MARTIN COUNTY, FLORIDA DEVELOPMENT REVIEW

STAFF REPORT

BARON LANDINGS PLAT

Report Number: 2024 0906 G076-011 Staff Report Final

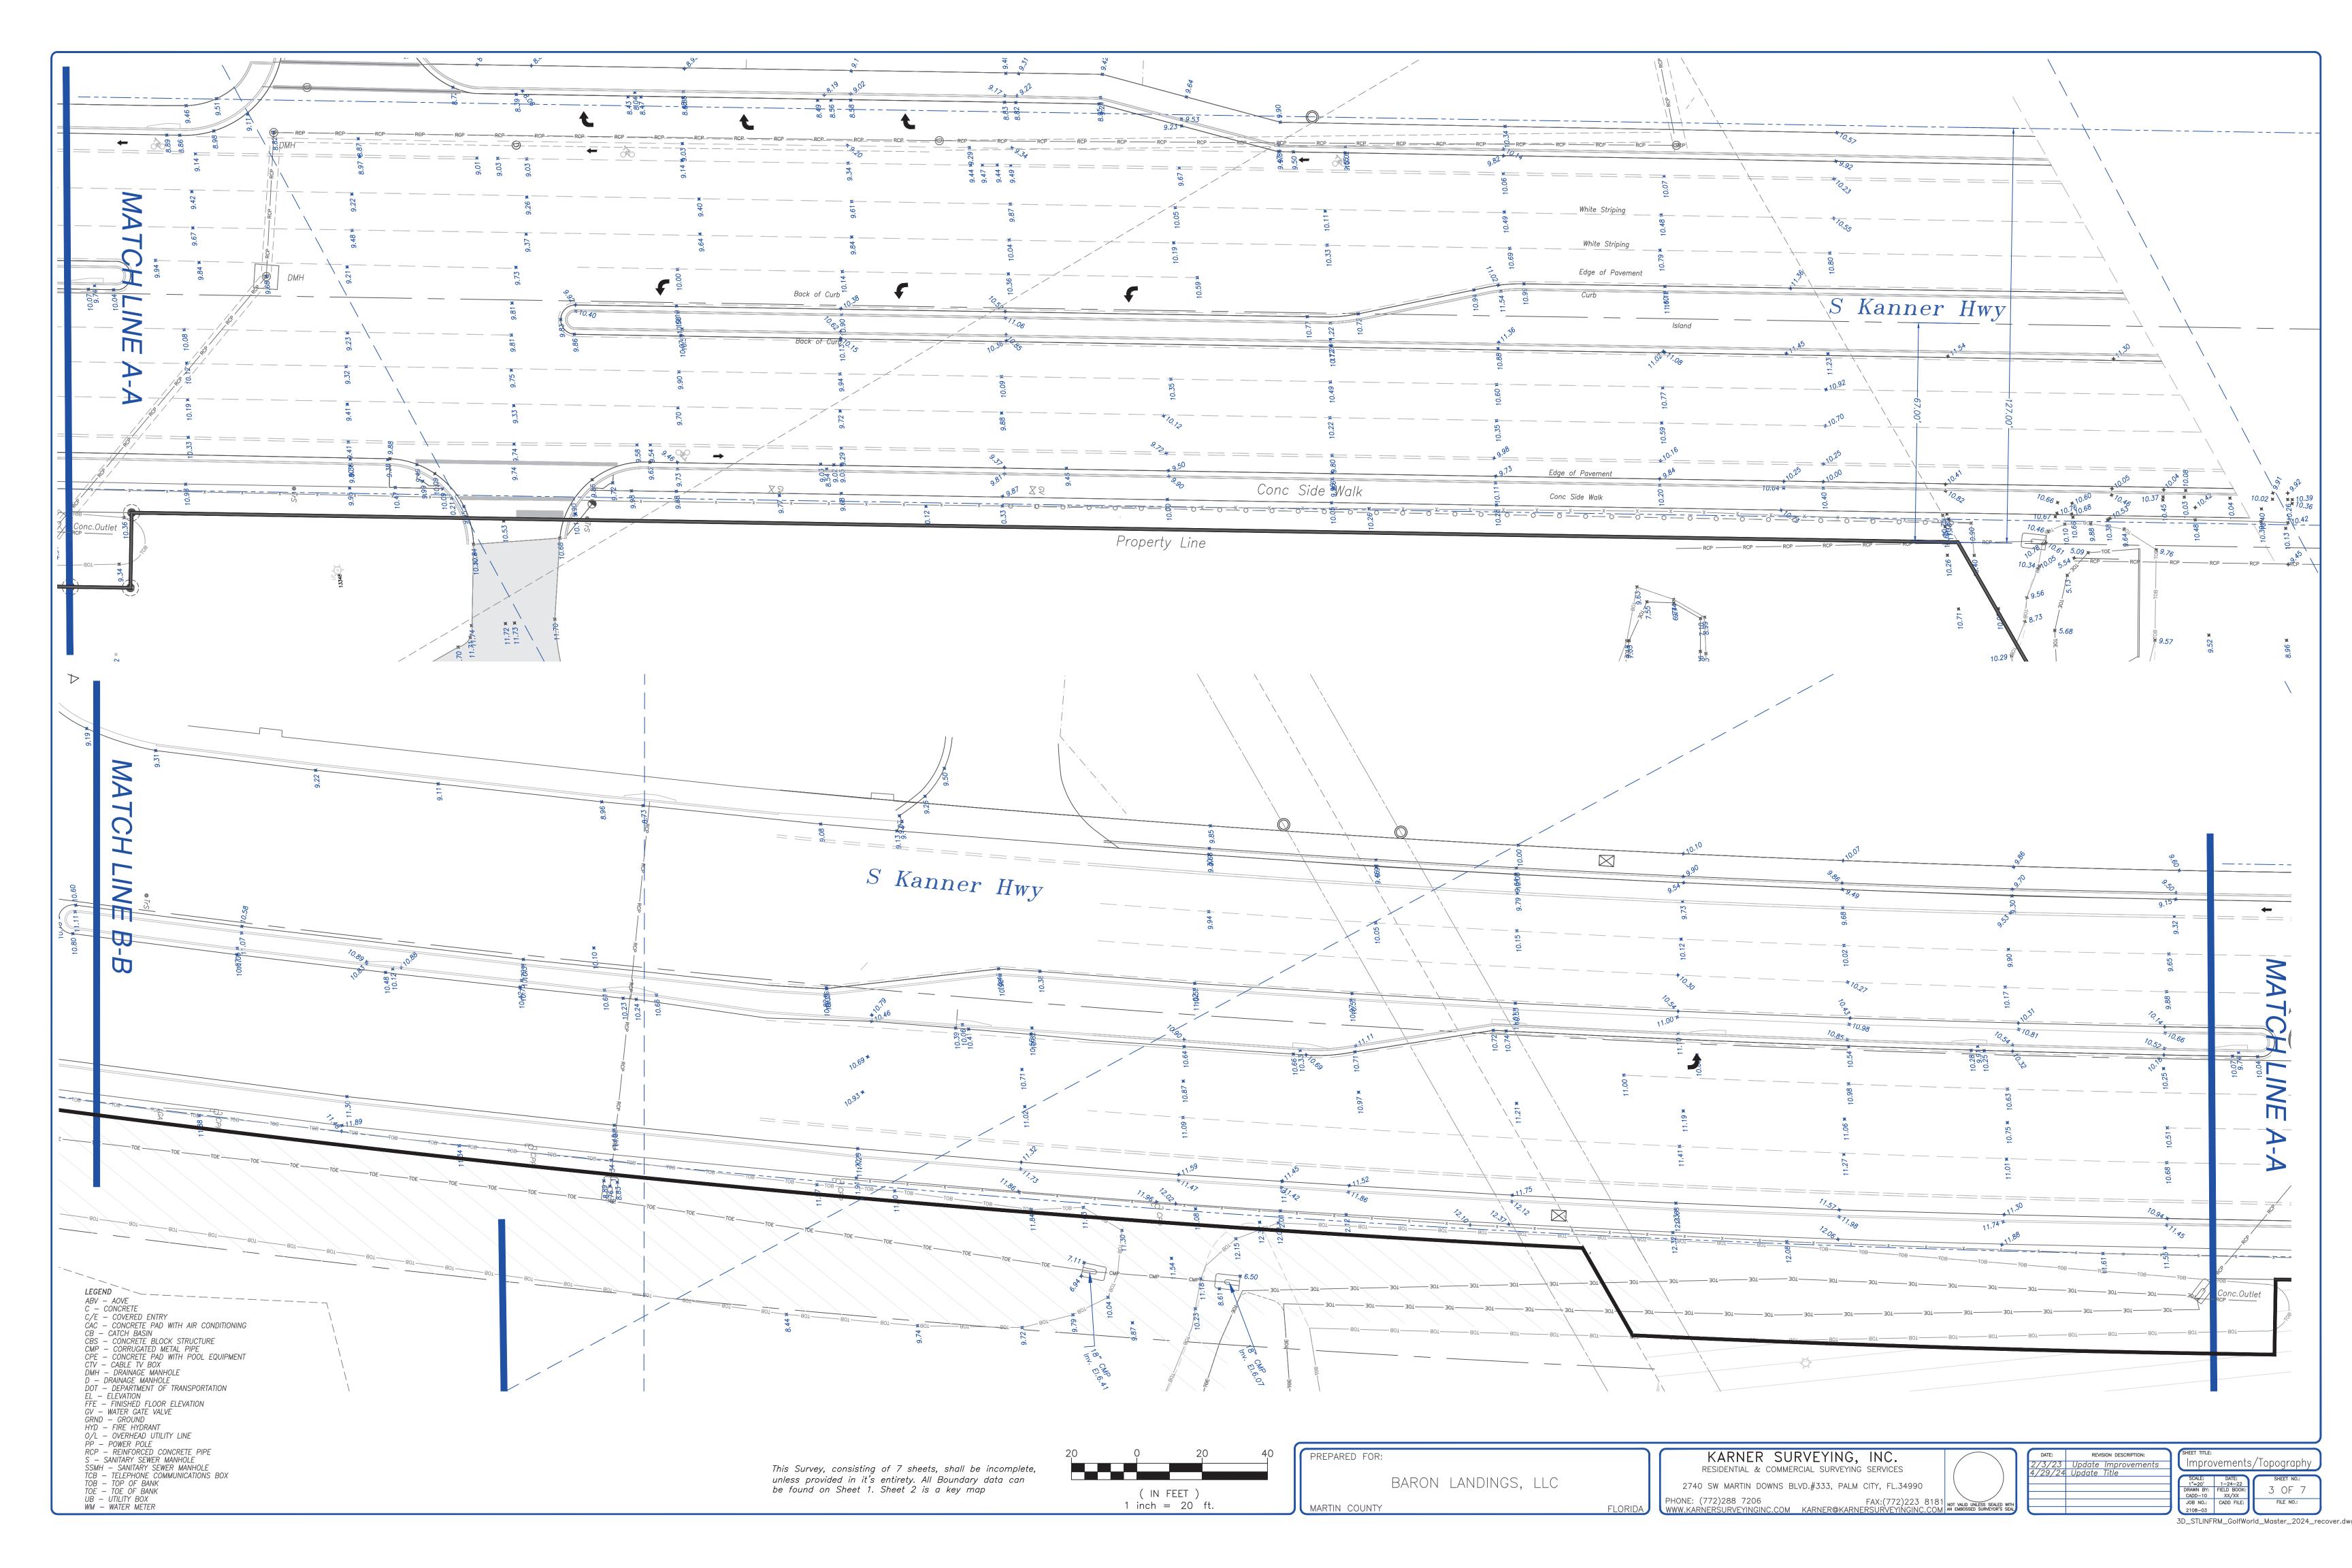
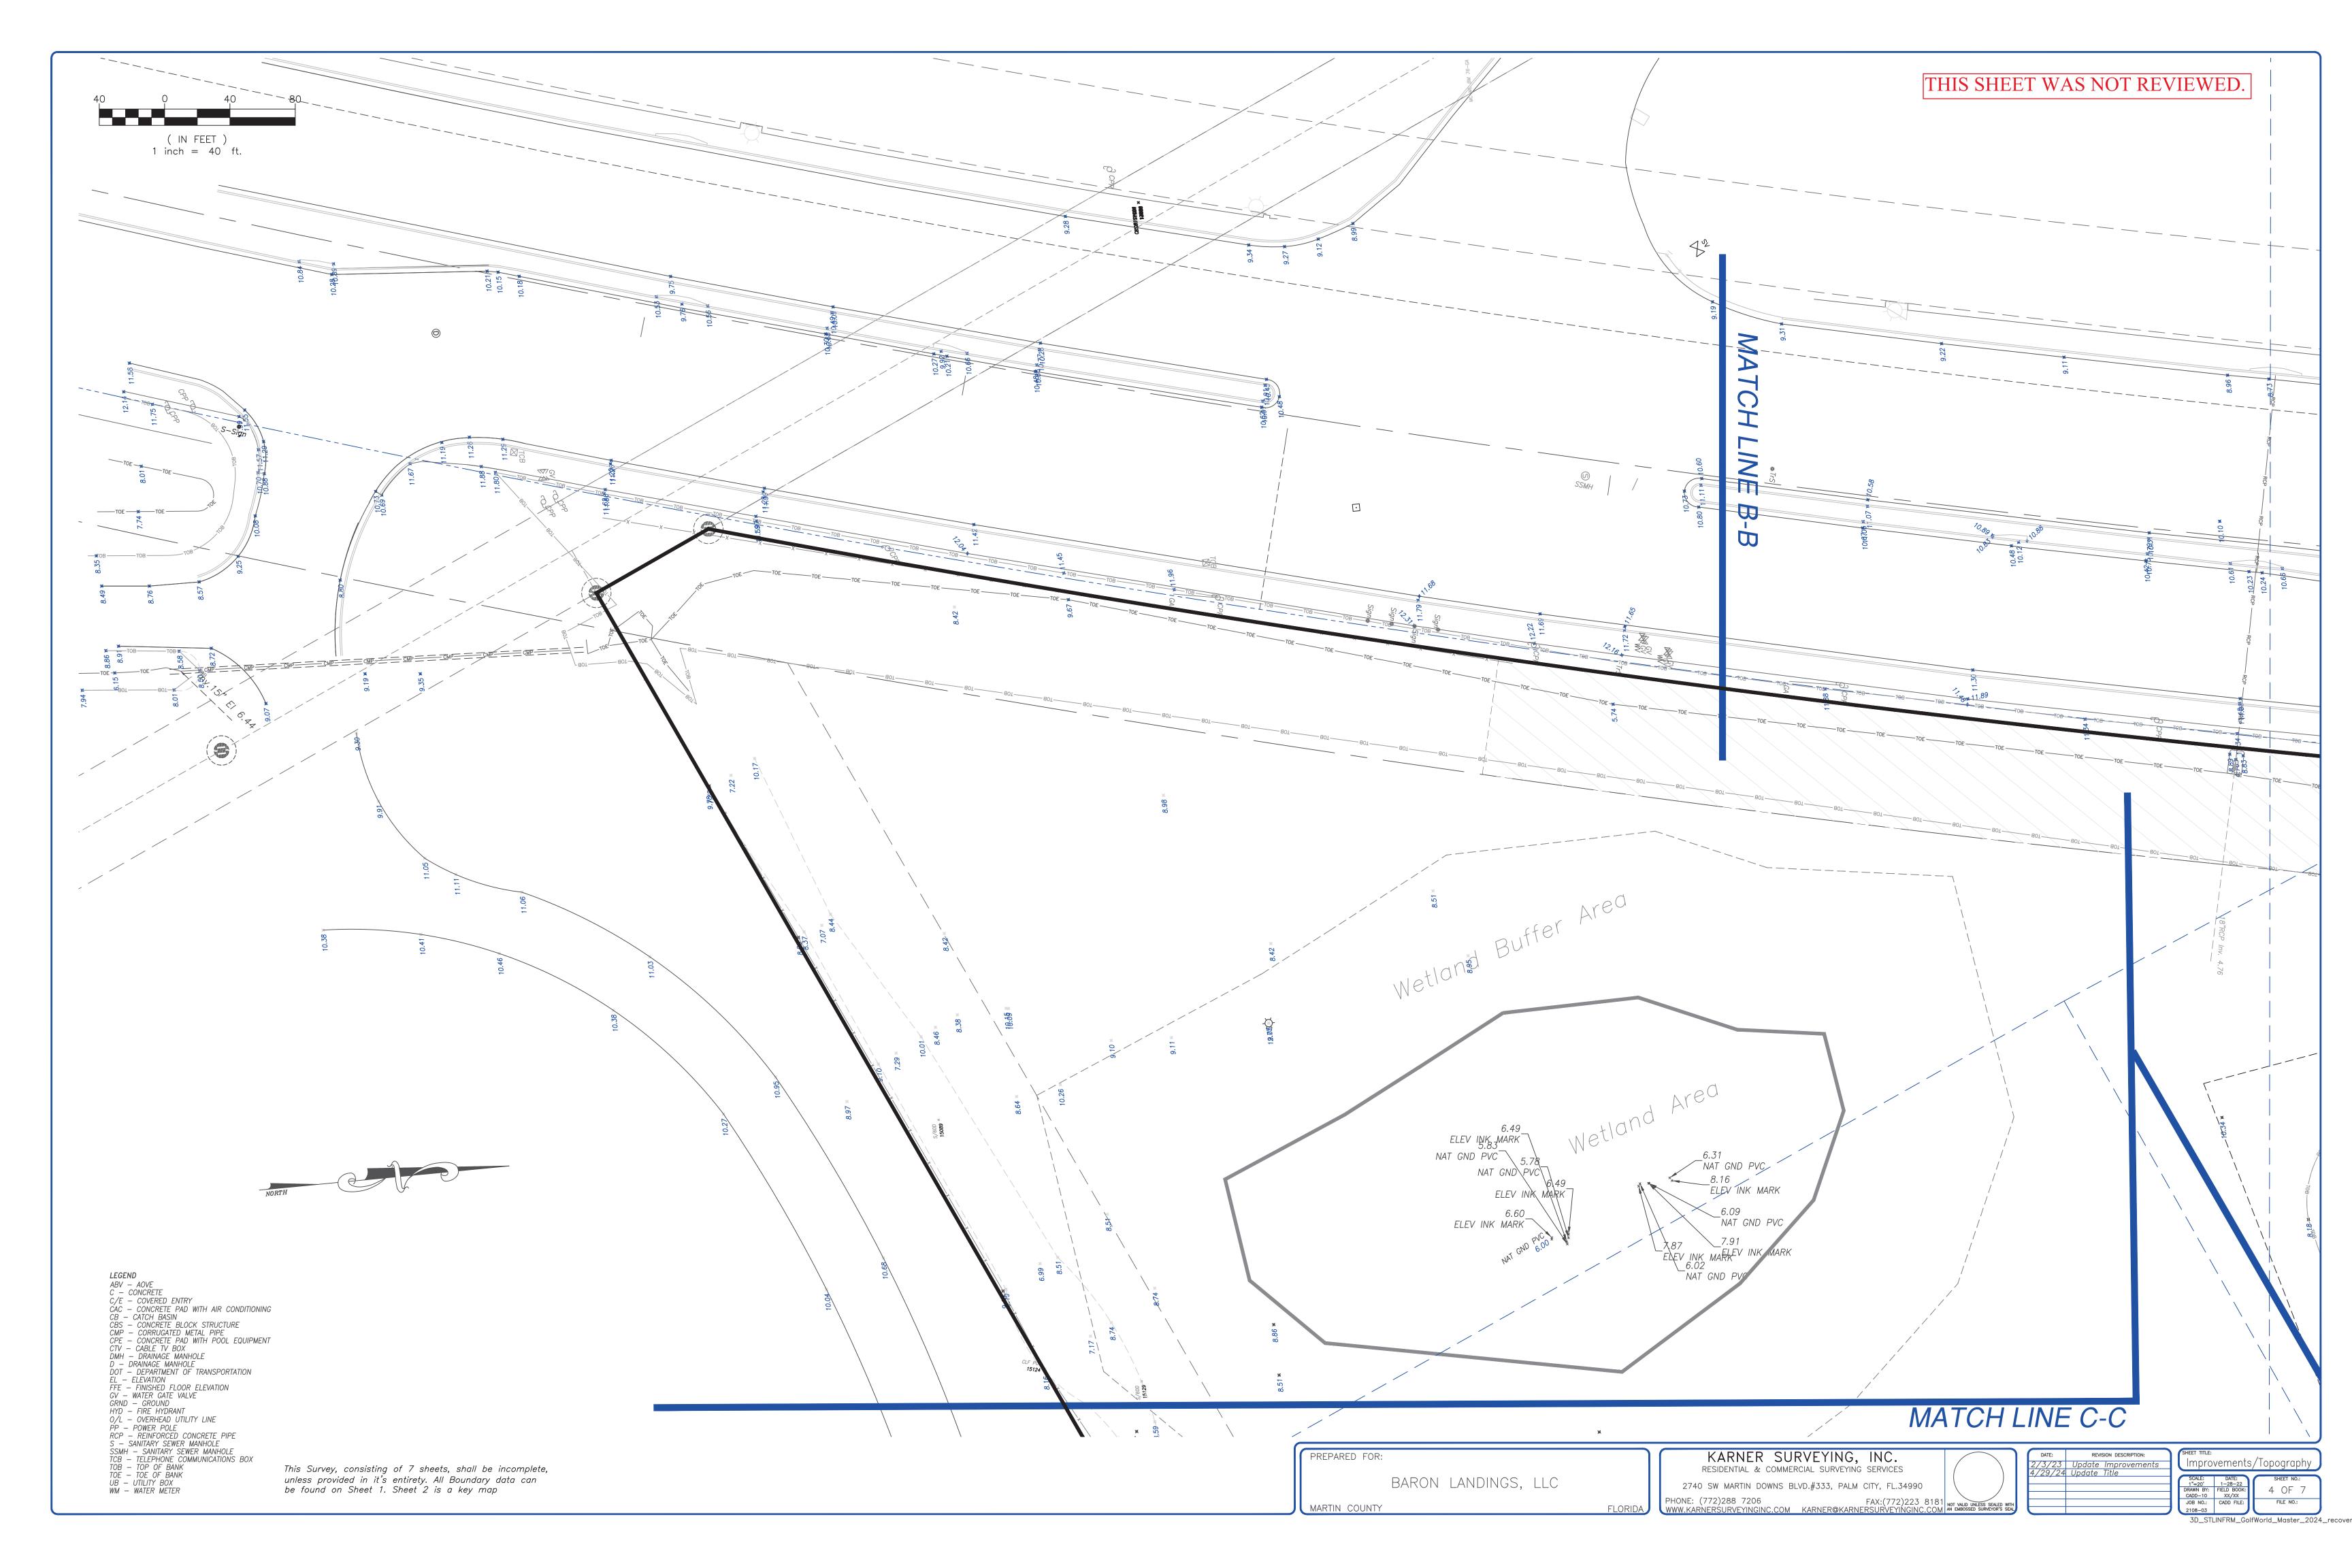
1.) PLEASE SEE COMMENT NOTATIONS INDICATING INCONSISTENCIES BETWEEN THE CLOSURE REPORTS AND THE PLAT.
2.) CORRECT THE INCONSISTENCIES BETWEEN THE OVERALL PLAT BOUNDARY CLOSURE REPORT, CORRESPONDING CLOSURE REPORTS AND WHAT IS LABELED ON THE PLAT.

MISSING LABEL ON SHEET 6 OF 6 OF PLAT

LABEL INCONSISTENCY ON SHEET 6 OF 6 OF PLAT

LABEL INCONSISTENCY ON SHEET 4 OF 6
OF PLAT

2.) PLEASE SEE COMMENT NOTATIONS INDICATING INCONSISTENCIES BETWEEN THE CLOSURE REPORTS AND THE PLAT.

MISSING LABEL ON SHEET 6 OF 6 OF PLAT

MISSING LABEL ON SHEET 4 OF 6 AND

- 1. Please see provided closure report mark-ups for inconsistencies between the closure report data and the data shown on the Plat.
- 2. New closure reports need to be submitted for all tracts and overall plat boundary with next submittal.
